Subject: **Request for Payment – MICT Berth 8, Phase I**

Subject: FW: Berth 8 Tender Design Report

From: lsdavid@philkoei.com.ph <lsdavid@philkoei.com.ph>
Sent: Saturday, 24 September 2022 3:54 pm
To: 'Rodel Samolde' <rodel.samolde@primebmd.com.ph>
Cc: 'Evangeline Mangulabnan' <evangeline.mangulabnan@primebmd.com.ph>; 'Marcel Greuter' <marcel.greuter@primebmd.com.ph>; 'psamoza@philkoei.com.ph' <psamoza@philkoei.com.ph>; 'Elenora Osalvo' <Elenora.Osalvo@primebmd.com.ph>
Subject: RE: Berth 8 Tender Design Report

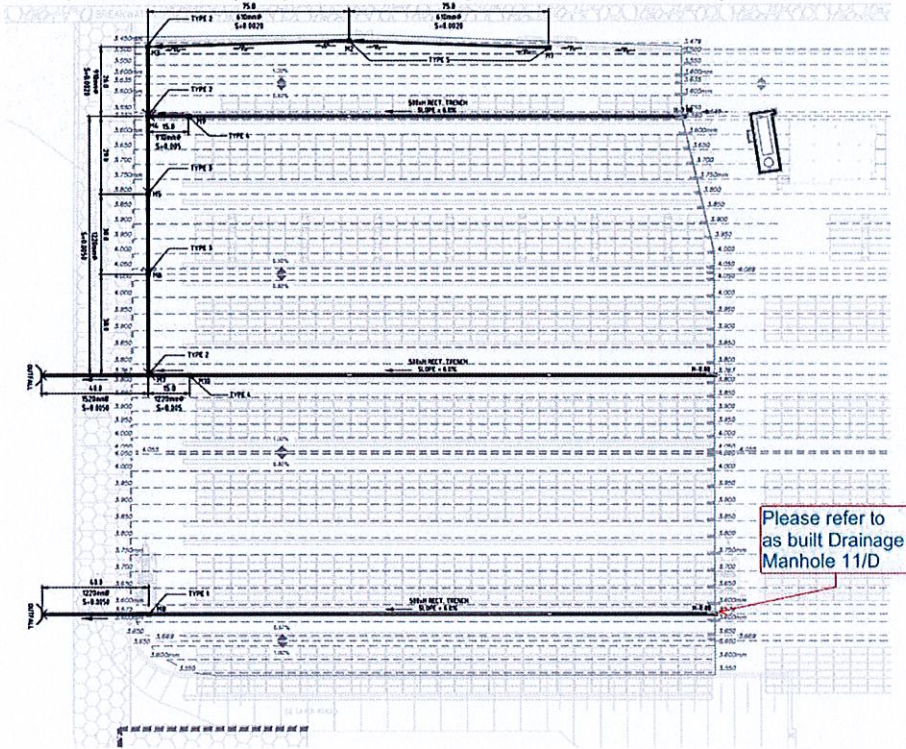
- 1) Please can you review the existing invert elevation based on as-built drawings provided. See below mark-up. Resending the as built for your easy reference.
- 2) Please can you provide drawing for invert elevation profile.

Upon our further review and evaluation of the drainage layout and identification of different invert levels at the junction of MH 11/D, the following have been considered in the updated drawings:

- Existing 750mm RCPC will be plugged/demolished to avoid obstructing the quay area as discussed
- Proposed trench size connected to 11/D adjusted to 800 X 2700 (grade=1%) considering difference in invert levels of existing RCPCs that will remain connected to said manhole
- Details of adjustments are shown in sheet D-16008
